Amendments to the Drawings:

Remarks / Arguments:

8 3. Amendments to Drawings:

Fig. 2

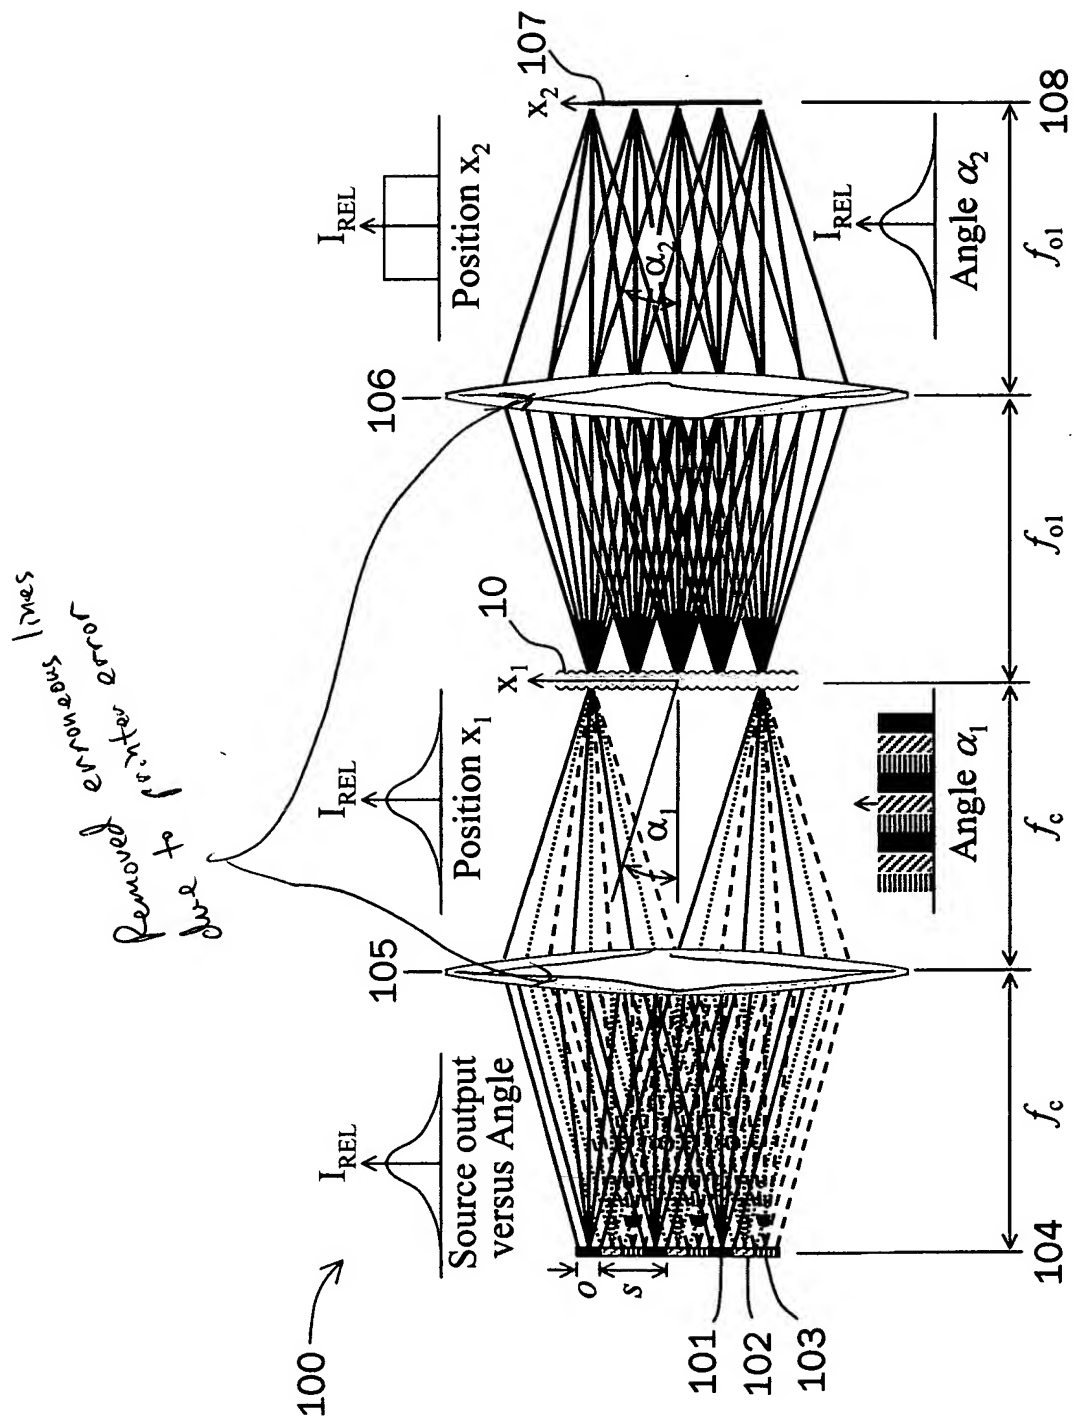
*Removed erroneous lines
due to printer error
and corrected for margin*

Fig. 7D

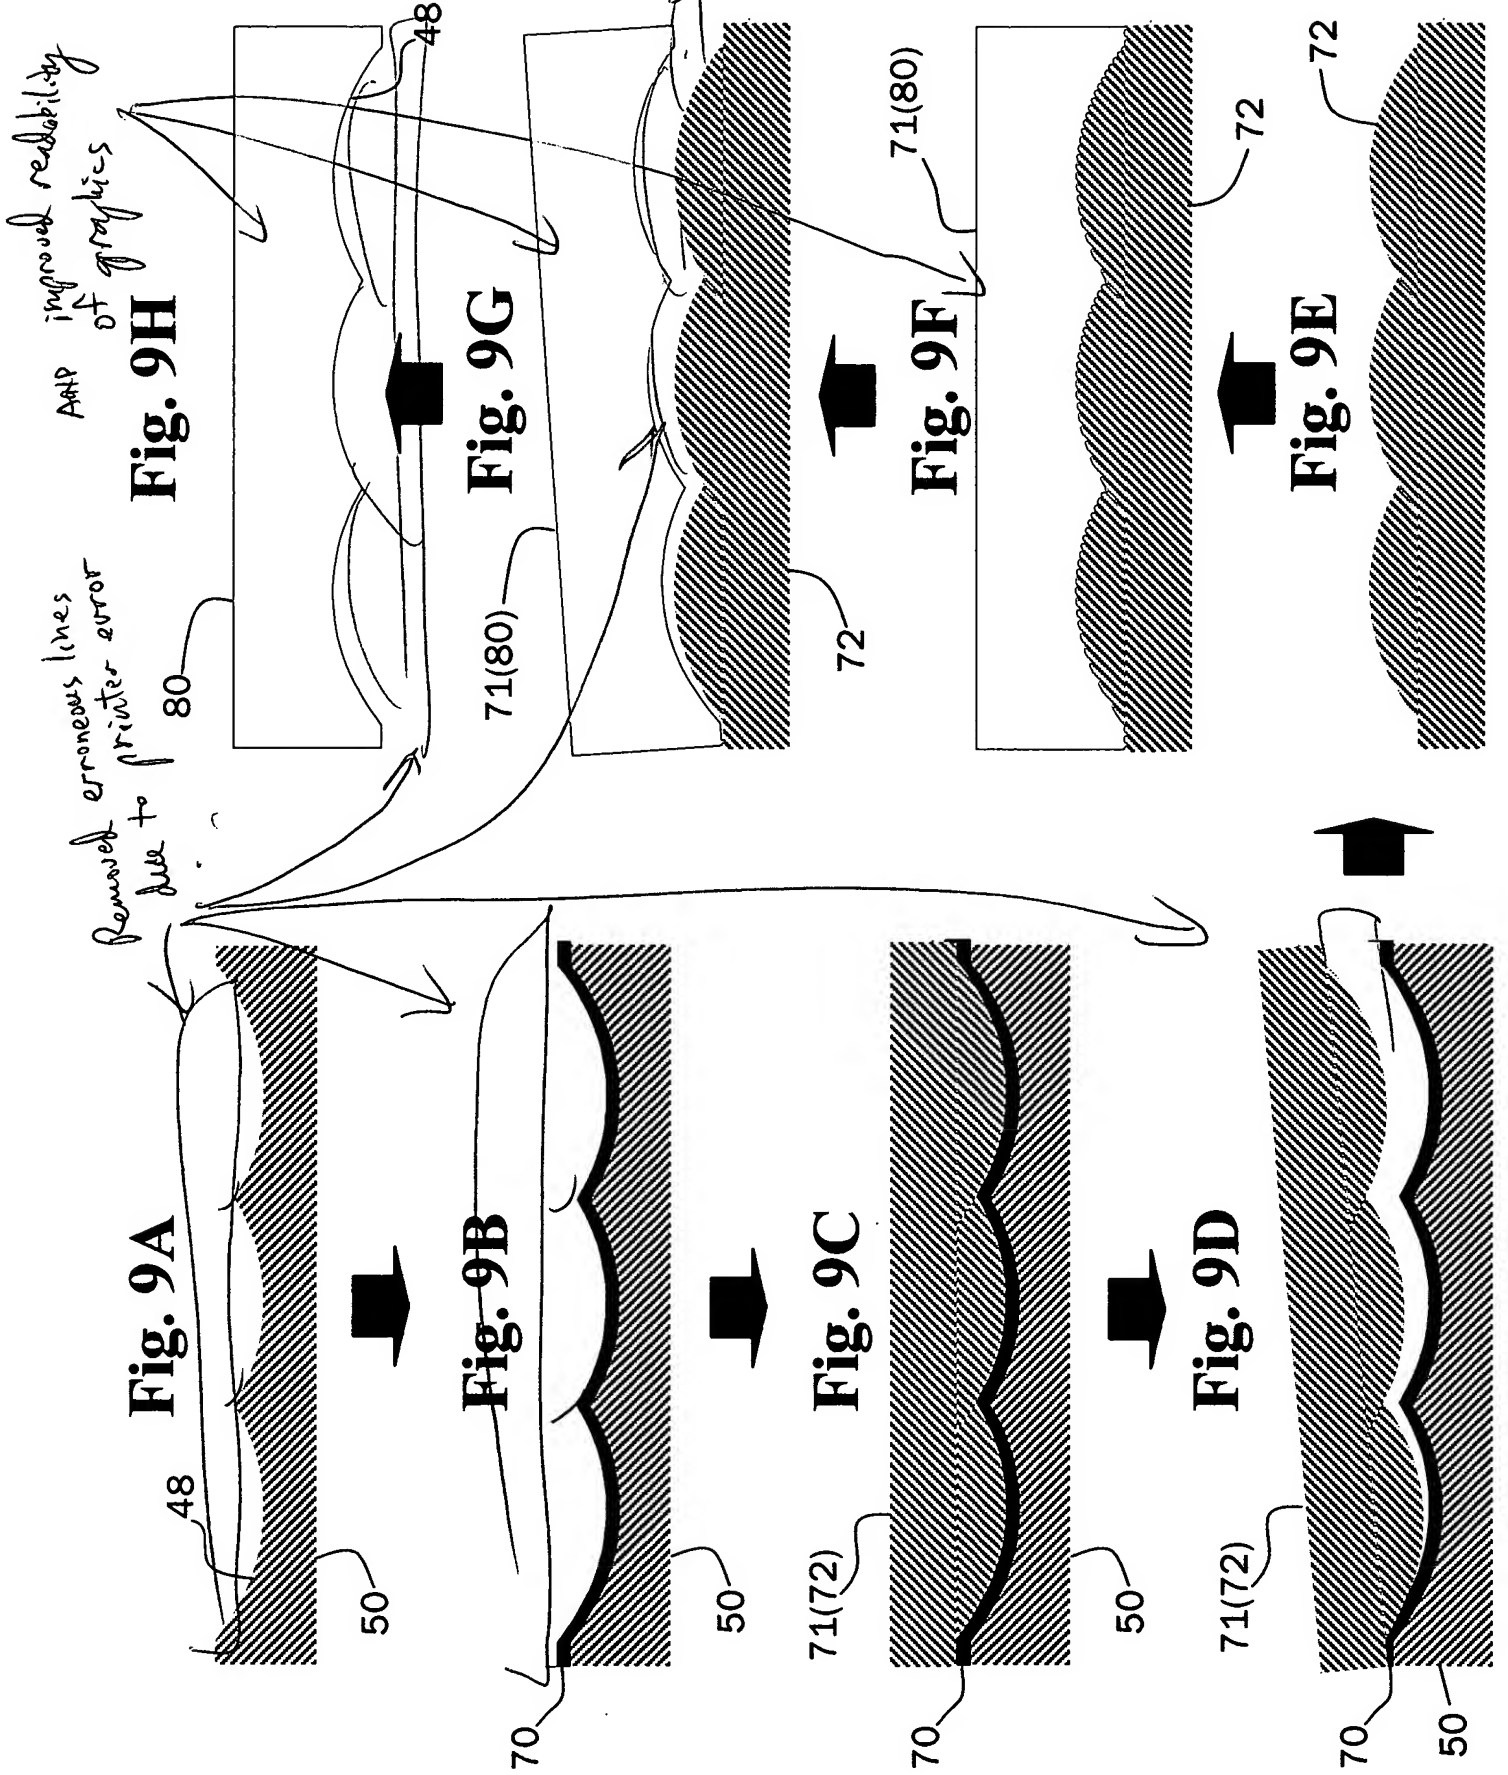
*Removed erroneous lines
due to printer error*

Removal of erroneous lines
from prior art to prevent error

Fig. 16A

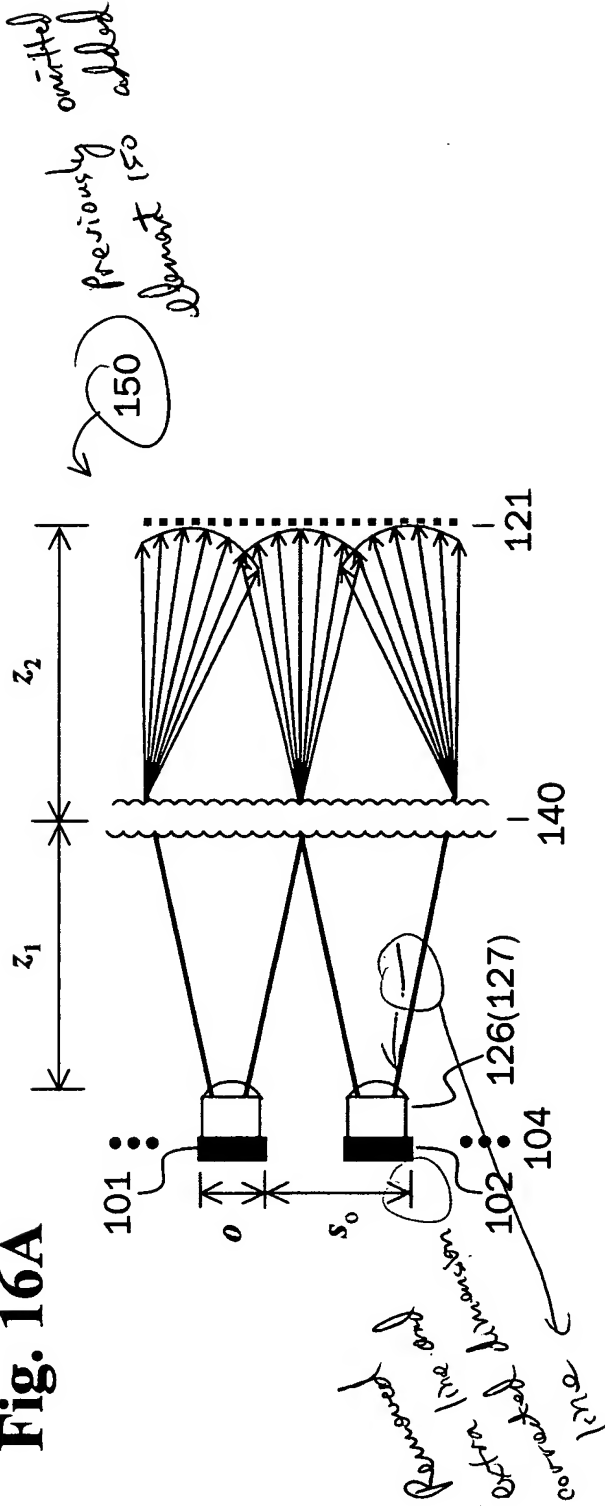
9 In amended Figure 16A, the previously omitted element numeral 150 has been added.

Remove the corner lines 123

Fig. 17A

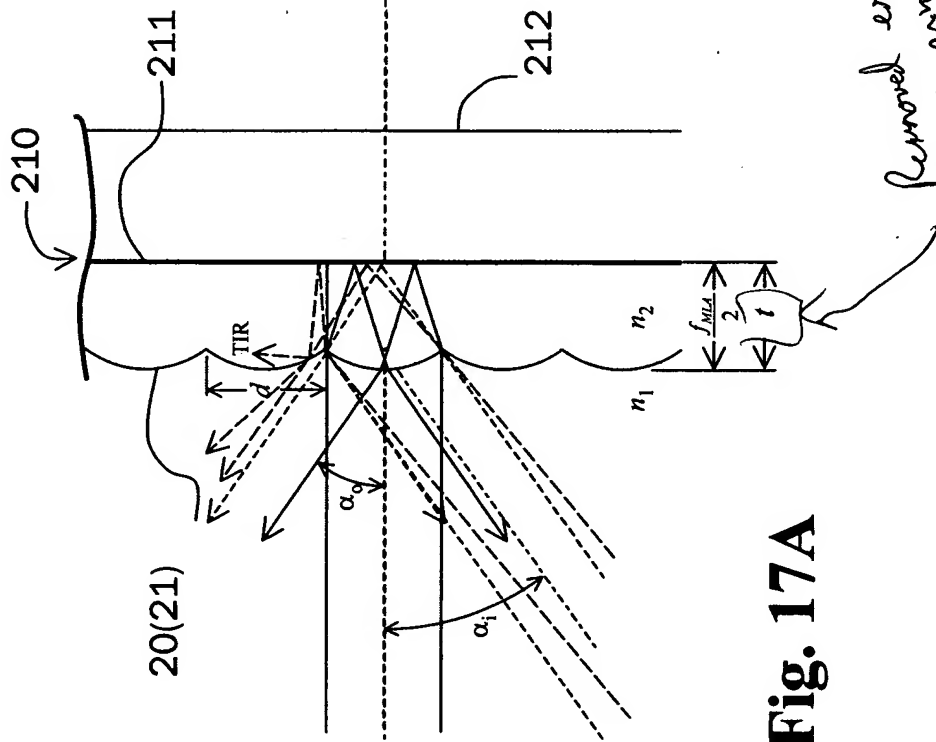
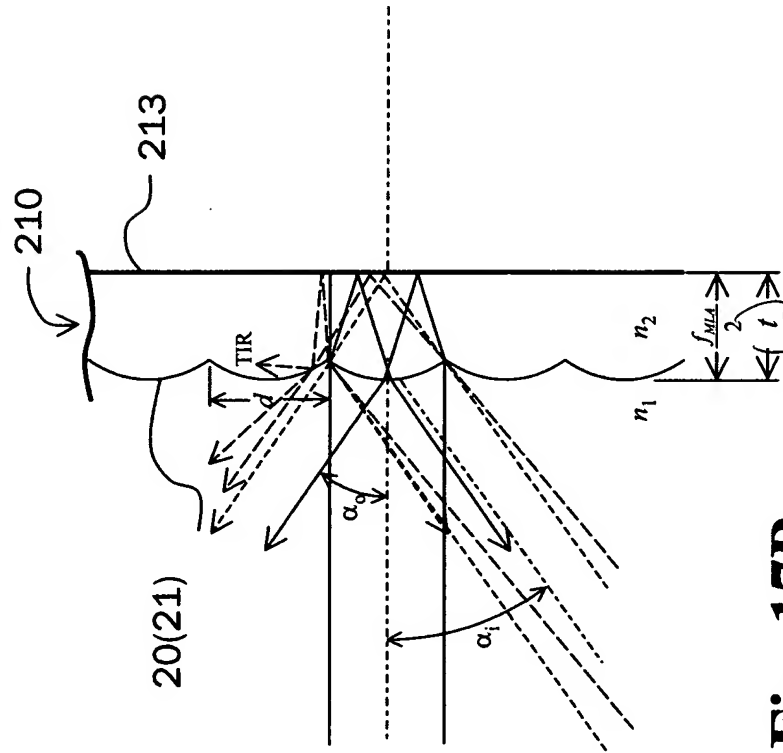
*Removed erroneous line
due to under over-
around text*

Replaced
"X₁-wave"
reference
term "waveplate"

Fig. 21

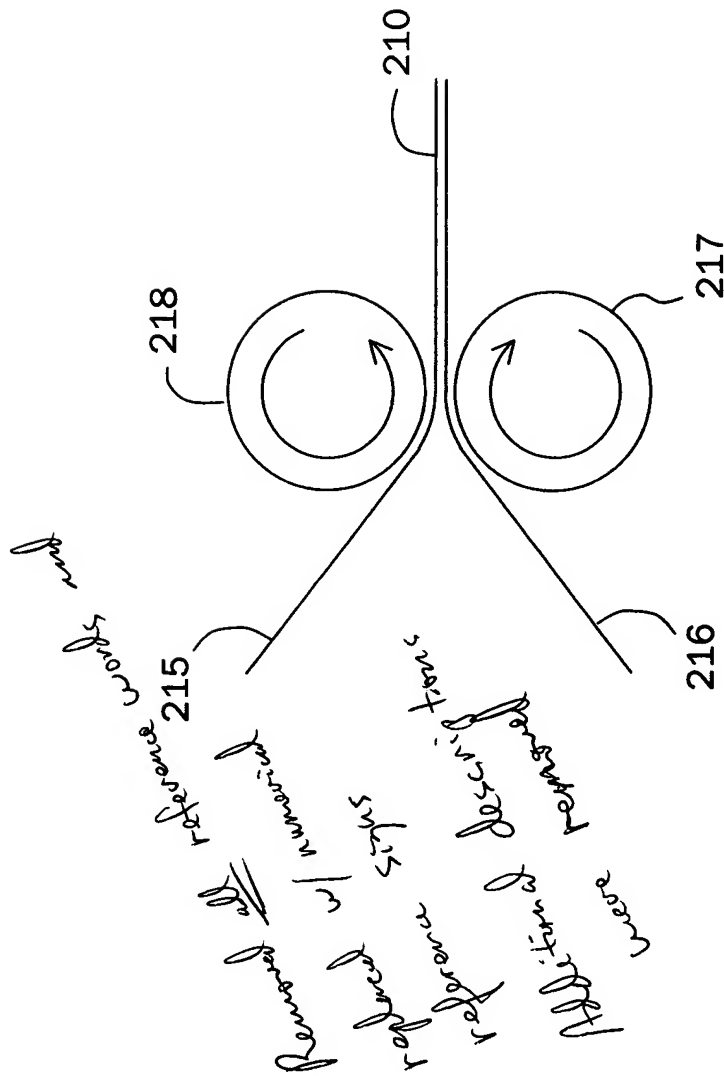
— Remove additional descriptive text title

Fig. 22A

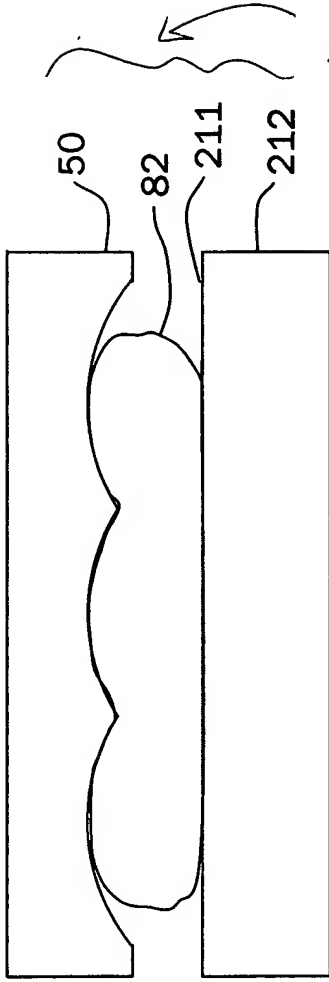
Removed reference words
and replaced with numerical
reference signs

Fig. 22C

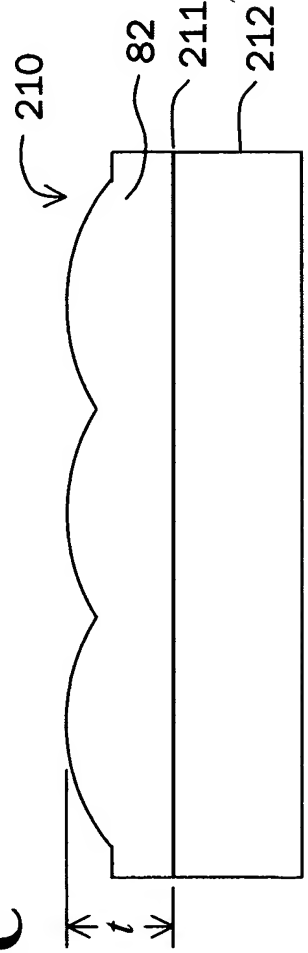
— removed additional descriptive text title —

Fig. 23A

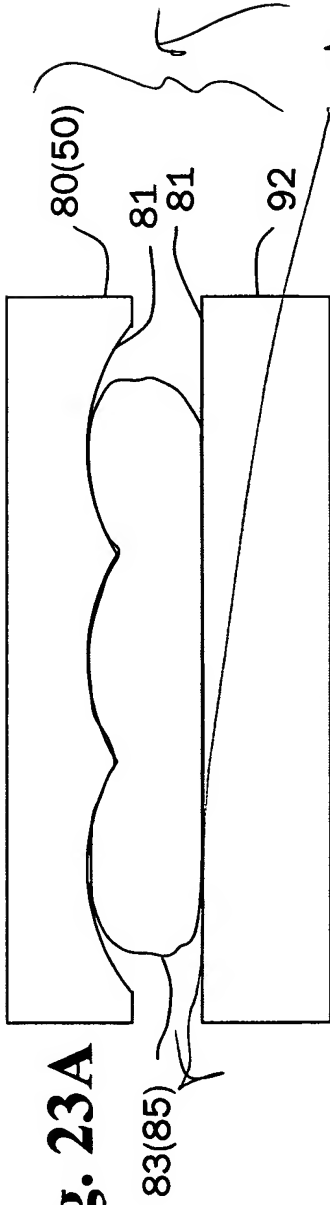
*Removed reference words
and replaced with numerical
reference signs*
